ACCESSIBILITY COMPLIANCE STATEMENT

Documentation Review

Our ref:	LP_22387
Project:	<p>NDIS SDA Housing 27-29 Stronach Avenue EAST MAITLAND NSW</p> <p>The development provides four (4) x 2 bed apartments for High Physical Support (HPS), two (2) x 1 bed apartments for HPS plus two (2) onsite overnight assistance (OOA) rooms. The proposed building is over two levels with a lift provided centrally within the building.</p>
Client:	<p>True Wealth Property Level 35, Tower One, 100 Barangaroo Avenue Sydney NSW 2000 Attention: David Clynych</p>
Documentation Review Date:	15 November 2022
Compliance Status:	<p>Compliant as Documented Refer to following compliance summary.</p> <p>Note – door to laundry in one-bedroom units is to be amended as per email correspondence 15-11-22.</p>
Applicable Legislation:	<p>The following legislation has been considered in the preparation of this Accessibility Compliance Statement:</p> <ul style="list-style-type: none"> — NDIS SDA Design Standards, Edition 1.1 2019 — The Commonwealth Disability Discrimination Act 1992 (DDA) — Disability (Access to Premises (Buildings)) Standards 2010 — Access Code for Buildings 2010 — The National Construction Code Building

Figure 1 | Overall Site Plan

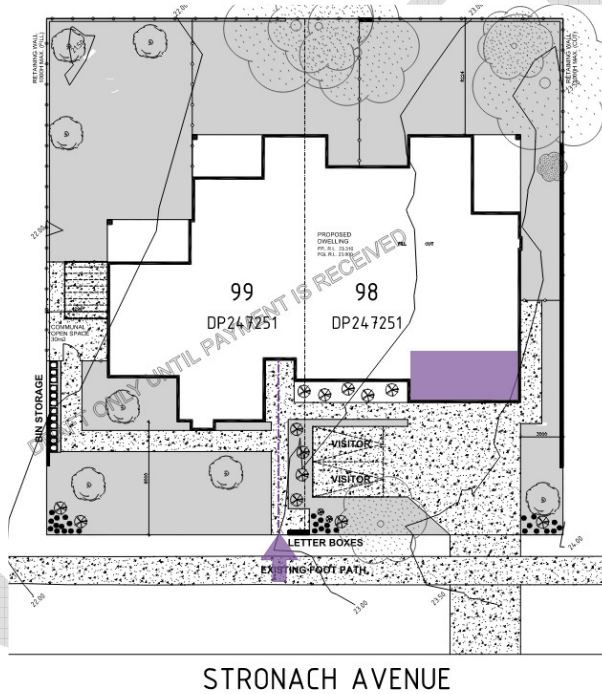
Item:	BCA Ref:	Compliance Status			Comments / Recommendations:
		Y	N	TBC	
3.1 Approach from Allotment Boundary	D3.2	Y	N	TBC	An accessible path of travel is provided from the allotment boundary along Stronach Avenue to the building entrance. On grade access is indicated.
3.2 Approach from Carparking	D3.2	Y	N	TBC	Accessible path of travel is provided between the accessible car parking spaces and the entrance lobby.
